ATTACHMENTS

Conceptual Site Model Topics

Comments on TUA Deliverables Red Hill Bulk Fuel Storage Are Oahu, Hawaii

August 14, 2018

Figure 1.1 Estimated Dip Directions in and Around Red Hill

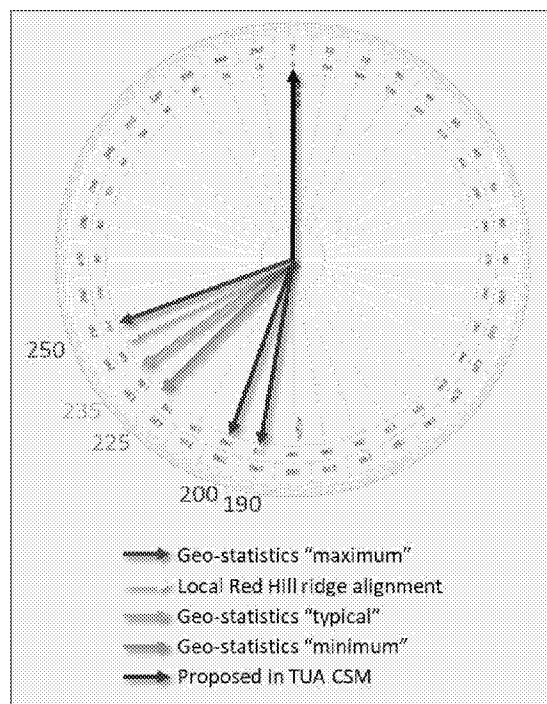
The values for the strike and dip of the lava flows reported by consultants to the Navy (CSM Report, page 5-2: *“True dip in the vicinity of Red Hill has been measured at angles of 10–12 degrees, with a strike of 190–205 degrees”*) differ from values that were obtained independently by the regulator SMEs via field observation and measurement and geostatistical analysis of barrel log data, which consistently exhibit lower dip values of about 5 degrees and more westerly strike values (Inset Figure 1.1). Although these differences may appear subtle, they are consequential for groundwater flow and potential contaminant transport paths. This is illustrated in Inset Figure 1.2, which presents pathlines calculated using the interim groundwater model, with values for the direction of anisotropy that differ by 10 degrees (particles depicted in red were computed with a more westerly direction of anisotropy reflecting a more westerly assumed dip direction).

Because there is a variety of data sources for dip and strike at Red Hill, it is appropriate to combine the data while considering their representative scales and quality to obtain a best-estimate at the scale of most interest to the fate-and-transport evaluation. Data sources at Red Hill include (a) close-quarters outcrop measurements such as obtained with a compass-clinometer, (b) surveys of visible outcrop from a distance that allow the geometry of a continuous bed-set to be followed for many tens or hundreds of feet, and (c) geostatistical analysis of the barrel log data. The resulting best-estimate derived from combining these lines of evidence can be to some extent corroborated by intersecting the derived plane with a digital elevation model for comparison with features observed in the field (Inset Figure 1.3).

Figure 2.1 Example Comparison of Seismic Profiles and Representation in the Interim Model

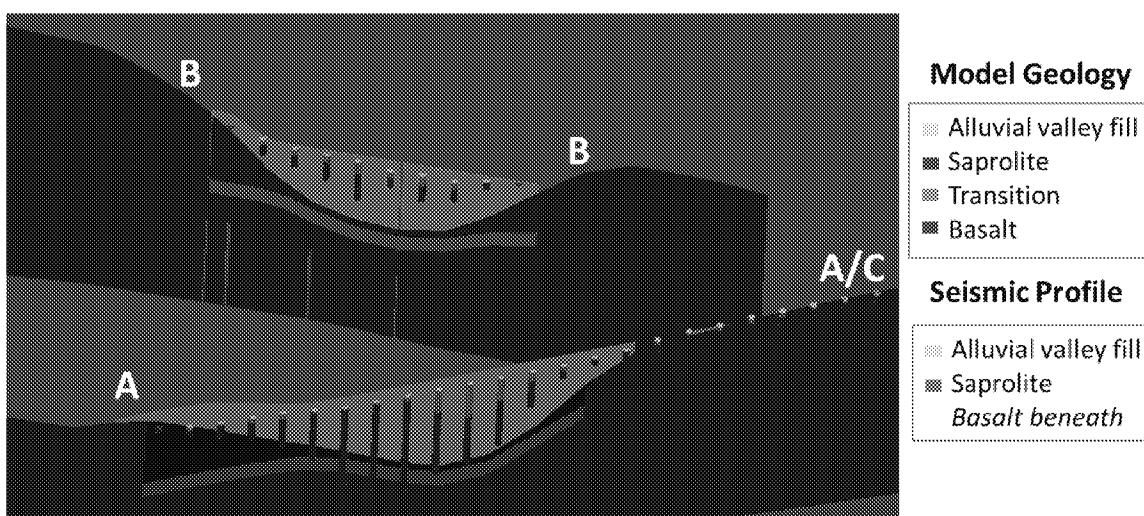
Review of the representation within the interim groundwater flow model files provided for courtesy review by the Navy of the saprolite/basalt interface depths and general trends (i.e., slopes) relative to the axis of the North and South Halawa Valleys suggests the saprolite is likely deeper down-valley and shallower up-valley than represented in the interim model. One consequence is that the point up-valley where the saprolite/basalt interface rises above water table may be more downslope than currently represented. If this is true, the role of the saprolite as a barrier to flow between valleys – particularly in up-slope areas – may be less protective than the current conceptual model indicates (Inset Figure 2.1).

There are at this time insufficient available data regarding the depth of the saprolite/basalt interface relative to the water table (particularly in North and South Halawa Valleys) to accurately and uniquely represent them in the model. Characterizing the three-dimensional (3D) extent and hydrogeological properties of the saprolite in each valley, including North and South Halawa Valleys, is difficult. Available data include a general CSM regarding basalt weathering and valley infilling; seismic geophysical analysis conducted along several transects; and a single detailed borehole geologic log that crosses the saprolite/basalt interface. Though the seismic data are very informative, ground-truthing is costly and only very localized. Available data from borings – such as the Halawa deep monitoring well – provide specific stratigraphic logs, but even these are accompanied by uncertainty regarding the appropriate depth to pick the interface (inset Figure 2.2). Consequently, uncertainty remains regarding the depth at which to represent the saprolite/basalt interface within North and South Halawa Valleys in particular, and regarding the protection afforded to Halawa Shaft by the saprolites acting as a barrier.

Available data which are overwhelmingly large scale and relatively low resolution (i.e., seismic profiles) must be interpreted in the context of the CSM and AOC to provide an appropriate representation for purposes of the flow and transport modeling. The solution to this problem likely lies in two parts: First, re-interpretation of the available data. When the currently seismic-inferred depths to the saprolite/basalt interface are compared to the CSM, the down-valley transects show a deeper interface depth than the current CSM would suggest while the up-valley transects suggest a shallower interface than currently believed. Interpolating between the down-valley and up-valley transects and extrapolating this trend up-slope from the most up-valley transect may help define where the saprolite is no longer beneath the water table and thus a barrier to flow and transport. Second, ground-truthing of the seismic data using test borings (this may already be planned as there is discussion of a test boring adjacent to Seismic Transect E near the Halawa Deep Monitoring Well [HDMW2253-03]). Additional ground-truthing is highly desirable, even though

costly, in targeted areas with maximal information benefit to provide (a) seismic velocities needed to better constrain the depth to the saprolite/basalt reflector and (b) interface elevations at key boring locations to condition the geophysical results.

Figure 3.1 Key fracture/hard rock characteristics as defined by the Interstate Technology Regulatory Council (ITRC, December 2017). Of those shown, the most important factors are the orientation of these features, the wall roughness, dip, aperture ranges, continuity and feature density.

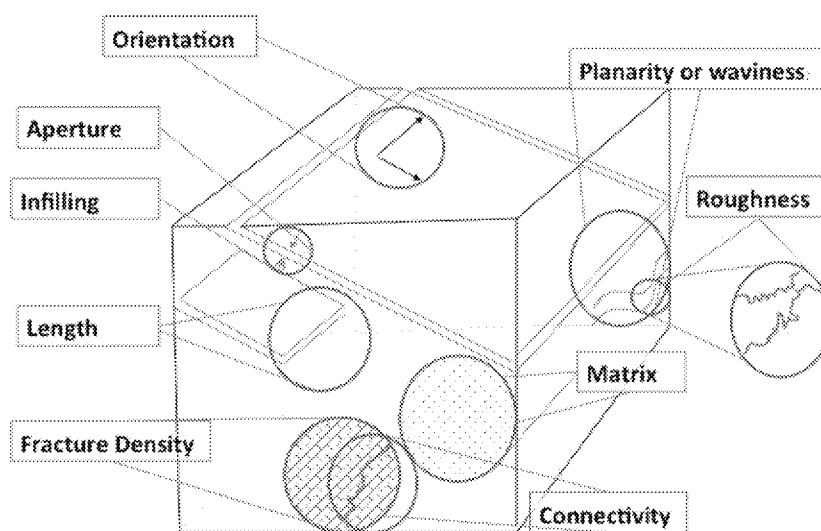
Voids, fractures, and related features in this shield volcanic setting will potentially allow for rapid transport of both LNAPL and dissolved-phase contaminants. These include lava tubes, bedding plane structures, fractures, etc. While mentioned in the CSM, there is no discussion or quantification of site specific facets. A good framing for hard rock and fractured systems is the ITRC fractured rock CSM schematic (e.g., Figure 3.1). Some of the more important factors are the orientation of these features, the wall roughness, dip, aperture ranges, continuity and density. While some of these aspects have been discussed in the CSM, none have been quantified (excepting dip, around which there are remaining questions), which would directly assist in considerations of contaminant F&T, particularly the LNAPL migration. For instance, based on the geologic barrel logging when the Red Hill tanks were installed, lava tubes are present beneath 13 of the 20 tanks; Tanks 1, 3, 4, 6, 8, 9, 13, 15, 16, 17, 18, 19, and 20. Lava tubes are expected to be a smooth-walled and distally continuous features (personal comm, Dr. Scott Rowland, U.H., 2018) that if intersected by LNAPL in the unsaturated zone would act as essentially an open-pipe transport conduits. In-filling, collapse and other post-deposition factors can affect how these conduits might behave, as noted in the Navy CSM. However, there is no site or area specific characterization of these important transport features in the CSM, absent which, little can be inferred regarding their potential effects on transport.

A portion of this issue is discussed in the bedding strike and dip discussion above. Based on the range of dip measurements by both the Navy and HDOH scientists, it is clear that there is significant variability in the dip and its azimuth. It also appears that there are changes in dip from the axis of the Red Hill Ridge to outlying areas. The Navy team does some good work in drawing analogies between current volcanic activity on the Big Island and past processes at work on O'ahu. We would simply note that on the Big

Figure 3.1 Example Figure Illustrating Hydrostratigraphic Features

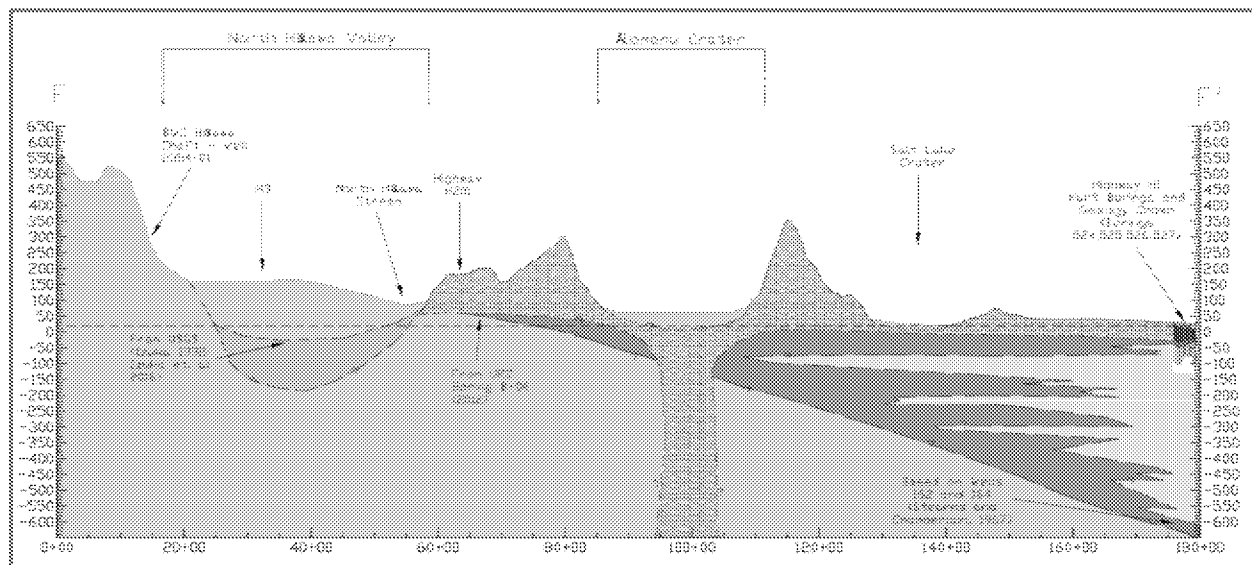
Gradients simulated by the interim flow model, as presented in the GPEC Report and determined from the interim model files provided for courtesy review by the Navy, do not comport well with gradients determined from synoptic data in and around Red Hill facility. While this is in part related to conditions local to Red Hill, analyses conducted using the interim model exhibit high sensitivity to conditions downgradient of Red Hill - specifically, in the area broadly represented by the caprock (GPEC Report Section 5.9). This suggests that although uncertain, because there are insufficient data available to uniquely and accurately specify the distribution and properties of downgradient geologic units, it is important to represent the hydrostratigraphy downgradient of the Red Hill facility as accurately as possible, using as one basis the overarching CSM regarding the distribution and properties of these features (Inset Figure 3.1).

Available information must be interpreted in the context of the CSM and AOC to provide an appropriate representation for flow and transport modeling. The solution to this problem likely lies in two parts: First, re-interpretation of the available data, and expanded use of sensitivity analysis and model calibration to help identify probable geometries and properties, including for example extending the saprolites down-valley, and differentiating Honolulu volcanics from surrounding sediments. Second, based on the anticipated results of sensitivity analyses conducted with this updated representation of

these features, consideration should be given to methods of data collection to better constrain the likely presence, extent and properties of these features. For example, other sources of information and data collection – such as airborne gravity surveys – may provide further evidence for the extents of some of these features.

Figure 5.1 Schematic of Recorded and Simulated Inflows

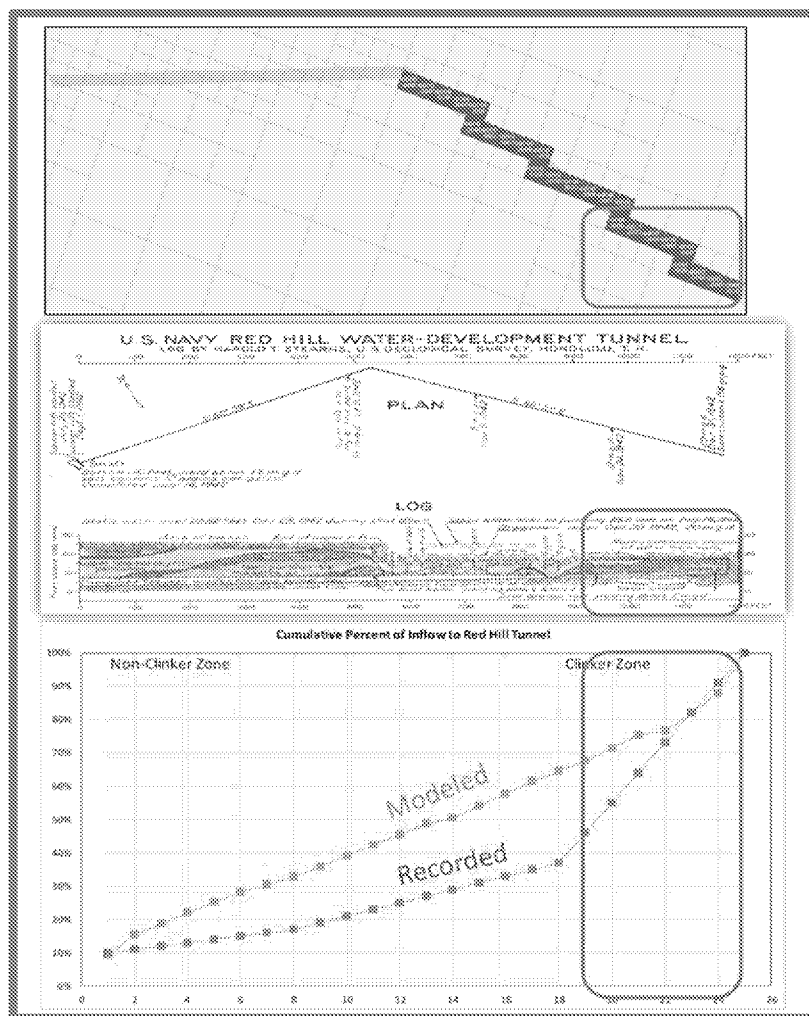
The interim groundwater flow model does represent Red Hill shaft as a linear quasi-horizontal feature rather than at a single vertical point, which is appropriate. However, the distribution of inflows to the eastern tunnel extension simulated by the interim model as determined from the model files provided for courtesy review by the Navy does not appear to match the inflow pattern encountered during tunnel construction (Inset Figure 5.1). During construction, a clinker zone was encountered that contributed more than 60% of the flow to the tunnel whereas the interim model simulates uniform inflow along the tunnel. This difference highlights two issues: first, there is heterogeneity present on a scale of many tens

to hundreds of feet that is not well understood nor represented in the interim model; second, the extent of capture developed by the tunnel may be more head-dependent than represented in the interim model. That is, the capture zone under high water level conditions may be dominated by seepage from this clinker at the end of the east tunnel, but under low water level conditions may be dominated by drawdown within the vertical shaft itself. Sensitivity analyses conducted with the interim model indicate that the model exhibits sensitivity to the potential presence of a clinker zone (GPEC Report Section 5.9).

The presence of large-scale heterogeneity is documented: however, the distribution and properties of these heterogeneities are not well known and cannot be perfectly represented in models. Despite this, consideration must be given to the role they may play in the

The final CSM and model should make a greater effort to evaluate the possible role of these heterogeneities – in particular, as an illustrative example, the Red Hill tunnel clinker – on calibration, zones of contribution, and contaminant transport. This may be accomplished for example by evaluating the zone of contribution under high water level conditions dominated by tunnel seepage, and under low water level conditions dominated by active pumping at the Red Hill shaft.

Figure 6.1 Example Comparison of Pairwise Head Differences from Synoptic Data with Simulate Head Differences from All Interim Models

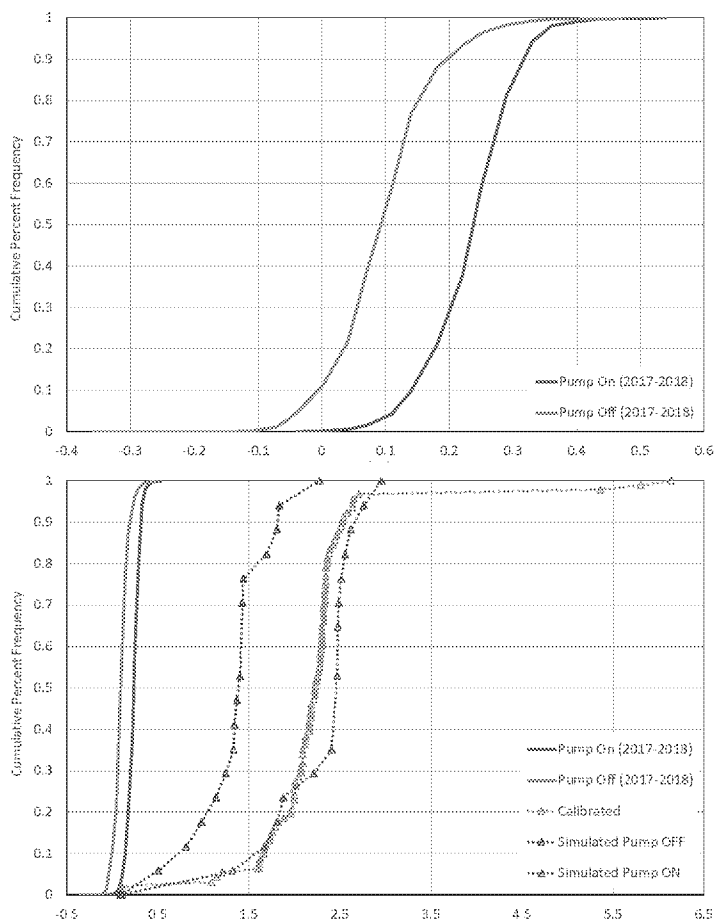
Hydraulic gradients determined from measured data are generally flat in and around Red Hill. On most occasions, gradients are to the southwest at a low slope, but occasionally they appear to be to the northwest and possibly north. The interim model outputs presented in the GPEC Report do not closely reproduce the magnitude or direction of these gradients. Flow in the calibrated interim model is dominantly Mauka-to-Makai, and most of the sensitivity-derived alternative models demonstrate flow toward Red Hill shaft at gradients that are 10 to 100 times higher than measured values. Although the sensitivity analyses do present a range of simulated gradients (GPEC Report Section 5.9), the distribution of simulated gradients across all models that were provided for courtesy review by the Navy does not match closely values derived from the synoptic data (Inset Figure 6.1).

The final CSM and model should focus on analyzing recent high-quality synoptic data to the extent possible, and down-weight analyses based on older data. Despite difficulties preparing water level maps, pairwise head-difference plots can show the effects of pumping on gradients and the frequency and magnitude of gradient reversals. Steady-state model calibration should focus on demonstrating a match

with regional patterns and with representative local gradients under pumping and non-pumping conditions. This combination is required to demonstrate that the model is useful for near-field transport to understand the available groundwater data, and for developing predictions of capture zones for Red Hill shaft and Halawa shaft to help evaluate risk and mitigating responses or strategies. Transient calibration will provide information on T, S, anisotropy, and possibly on the geometry of features such as the saprolite but is not a substitute for obtaining reasonable mean-centered correspondence to the measured gradients (or pairwise head differences).

Figure 10.1 Example Figure Illustrating Variable Discharge to Pearl Harbor

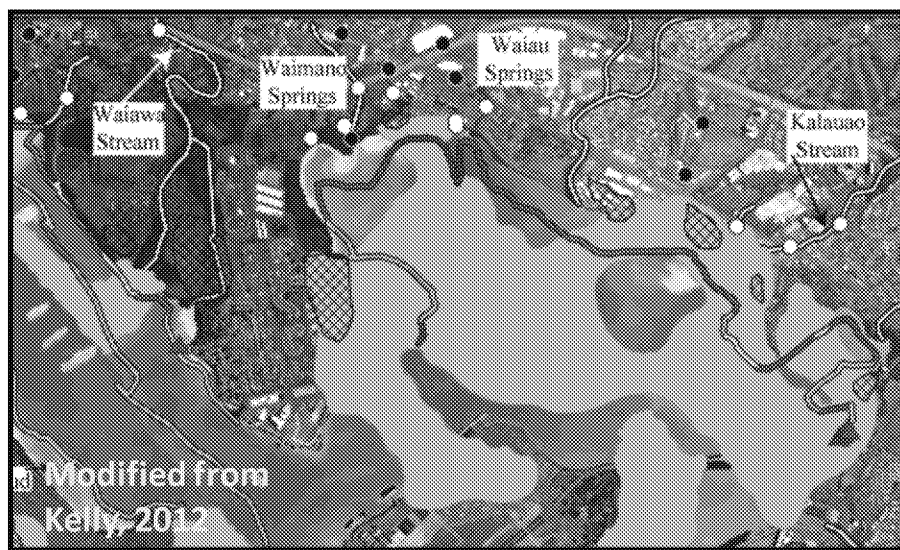
Gradients simulated by the interim flow model do not comport well with measured gradients in and around Red Hill facility. While this is in part related to conditions local to Red Hill, the interim model exhibit high sensitivity to conditions downgradient of Red Hill. The interim model represents the downgradient discharge (outflow) from the model to the saline water bodies (Pearl Harbor Estuary and offshore areas south of Pearl Harbor) via a general head boundary (GHB) with some areas exhibiting intervening high-conductivity cap rock (GPEC Report Section 4.4). The GHB allows flow based upon an ascribed elevation and an intervening resistance between the boundary and the aquifer. In this configuration, groundwater is simulated to preferentially flow to the eastern part of Pearl Harbor Estuary. However, muds and volcanic ash on the bottom of Pearl Harbor may impede flow leading to more flow from Moanalua Aquifer to the Waimalu Aquifer. Flow from the Moanalua Aquifer to the Waimalu Aquifer where spring systems and large pumping centers create significant drawdown could result in a flow path beneath the Red Hill facility to the northwest.

The approach to simulating the groundwater flow to the Pearl Harbor Estuary and the southern offshore regions needs further work. Although uncertain in extent and character, it is important to represent the downgradient outflow conditions as accurately as possible, using as one basis the CSM regarding the distribution and properties of these features, and also other sources of information (Inset Figure 10.1).

The solution likely lies in two parts: First, re-interpretation of the available data, with expanded use of sensitivity analysis and model calibration to help identify probable geometries and properties. Model refinements may include using multiple layers to simulate the caprock and include older alluvial sediments and the muds and tuffs that blanket the floor of Pearl Harbor. Second, based on the anticipated results of sensitivity analyses conducted with this updated representation of these features, consideration should be given to methods of data collection to better constrain the likely presence, extent and properties of these features.

Figure 9.1 Example Terminal Electron Acceptor (TEA) Map – Dissolved Oxygen

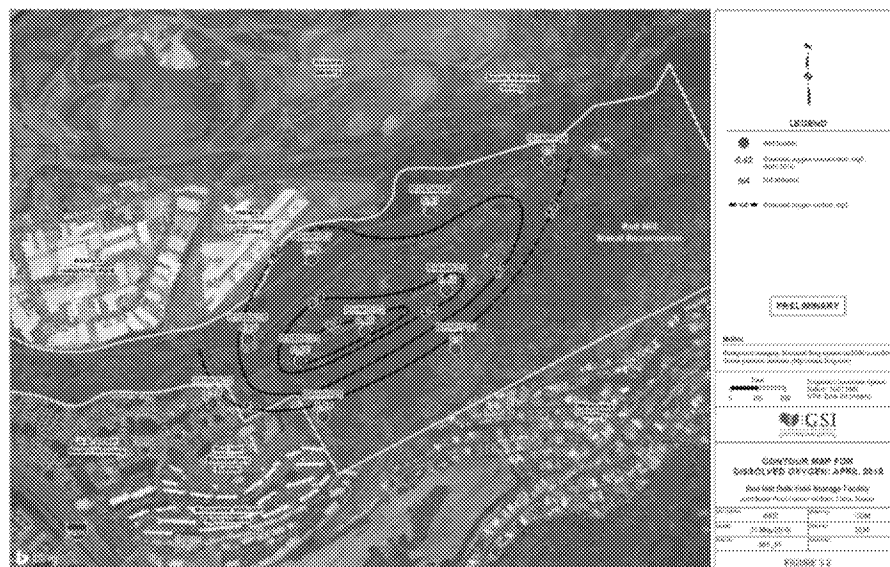
Interpretations of water quality data presented in the CSM Report and GPEC Report are in places non-conservative, and conflict with other lines of evidence and with conclusions reached by regulator SMEs. Example 1: The Navy consultants dismiss some detected results out of concerns for data quality (CSM Report Section 7.2 and Appendix B.7). Though in some instances justified, these concerns do not address all detected results, and from the regulatory perspective, any reported detections that are not qualified are evidence of impacts. Example 2: Independent analyses of TEA data presented and discussed in CSM Report Section 7.3.2 and Appendix B.4 and GPEC Report Figure 6.3 as indications of natural attenuation (e.g., Inset Figure 9.1), dissolved phase contaminant detection frequency and distribution (inset Figure 9.2), and hydraulic gradients, suggest transport occurred not just to the southwest but also to the northwest and possibly northeast of the facility. Example 3: The distribution and concentrations of general chemistry data (i.e. major ions, specific conductivity, and pH) show a poorly-mixed system inconsistent with the Navy CSM of robust flow from upslope recharge areas to Red Hill Shaft. The chemistry is highly variable with chloride concentrations spanning over an order of magnitude and is more suggestive of sluggish down-slope flow and compartmentalization (inset Figures 9.3 and 9.4).

Before developing the transport model, it is important that the CSM encompass reasonable interpretations of available water quality data. The CSM should, at this stage, allow for “alternative hypotheses” of at least equivalent likelihood of LNAPL impact to groundwater versus the current hypothesis of there having been no impacts. The final groundwater flow model, when it reasonably represents hydraulic gradient directions and magnitudes in the vicinity of Red Hill ridge, would be anticipated to underpin a contaminant transport model that demonstrates a reasonable match historical sample results (contaminants and TEAs, etc.), thereby demonstrating that the model is useful for near-field transport to understand the available groundwater data, and for developing predictions of contaminant transport and fate to help evaluate risk and mitigating responses or strategies.

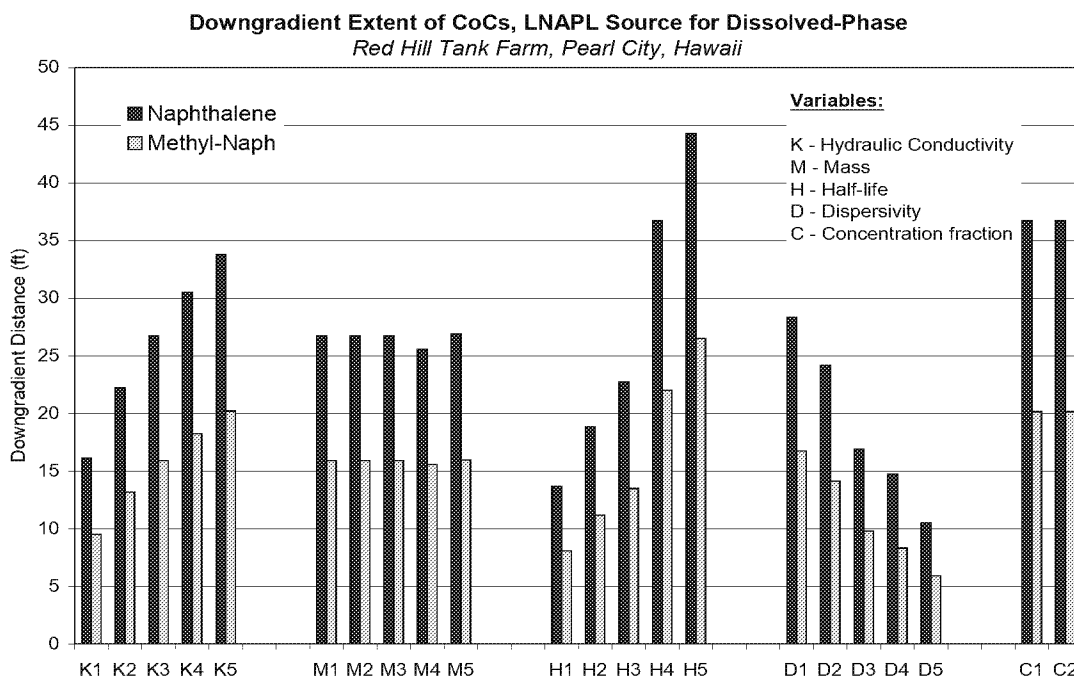
Much less is known with respect to the potential LNAPL distribution in the subsurface that is the source of these groundwater impacts. Simplified transport estimates suggest that for a wide range of general site parametric conditions, the expected downgradient extent of these compounds is typically less than 100-ft away from the LNAPL source feeding the dissolved-phase impacts (Figure 10.2 below).
